# BETHEL HIGH SCHOOL BUILDING COMMITTEE

September 22, 2010

## MINUTES

## **Bethel High School Building Project Post Facility Report Update**

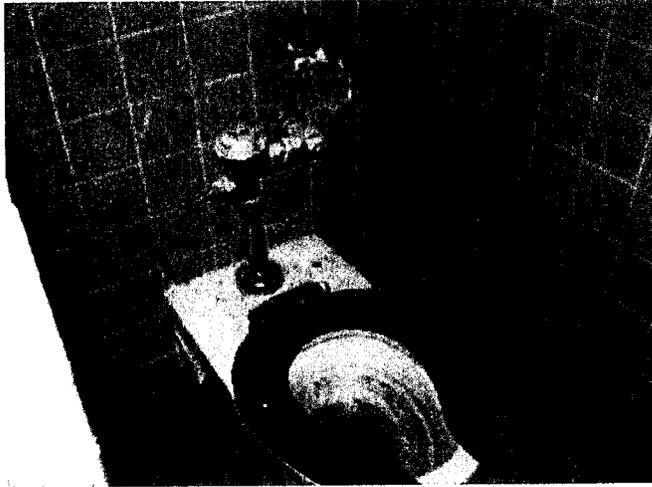
As you see in this photo the base of the toilet displays cracks and fluid leaks. This is a typical condition that can be observed on many of the fixtures. Also in this photo is the new floor tile and wall paint that was installed and was not part of the project.

These fixtures are bagged off as a result of non-functioning waste drainage and leaking water into the wall from dried out joints.

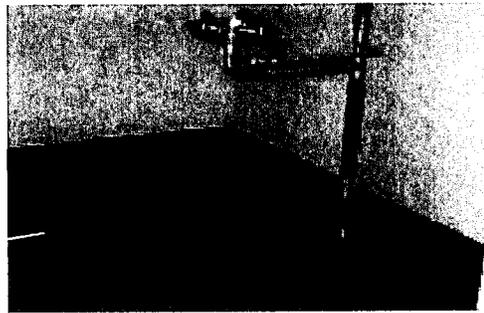
On September 15, a leak was discovered in the D-Wing, lower level. This leak is in a 2 ½ inch water feed for the upper floors. Our plumbing contractor while inspecting other plumbing issues within the building, checked this leak out and reported that this leak was the result of poor craftsmanship in the soldering of these copper pipes.

As a result of this condition, the contractor has been asked to inspect other areas for possible leaks or questionable installations.

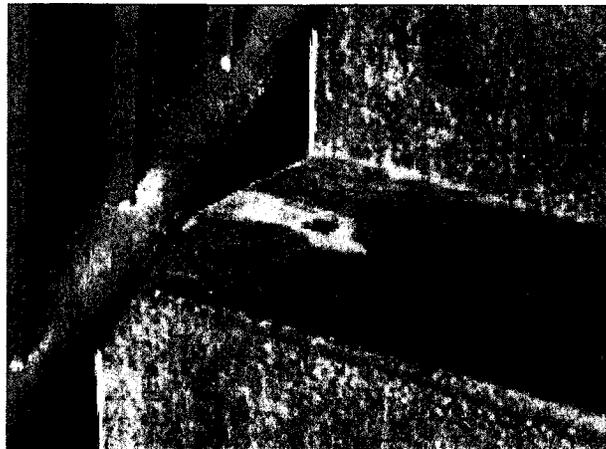
Throughout the building, within the stairwells the old railings were cut out as part of the renovation. This project resulted in metal stubs protruding from the concrete. The rough unfinished appearance creates an unsightly condition as the metal has started to rust and discolor the concrete.

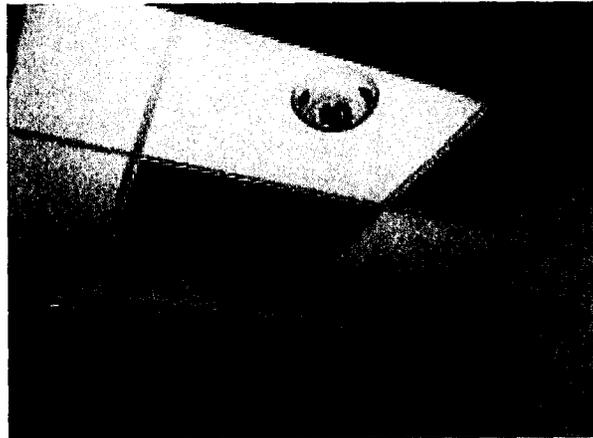
This is an area on the second floor that shows an uncompleted ceiling grid with metal objects hanging from the ceiling above. Numerous areas had unfinished areas that were completed by the custodial staff.
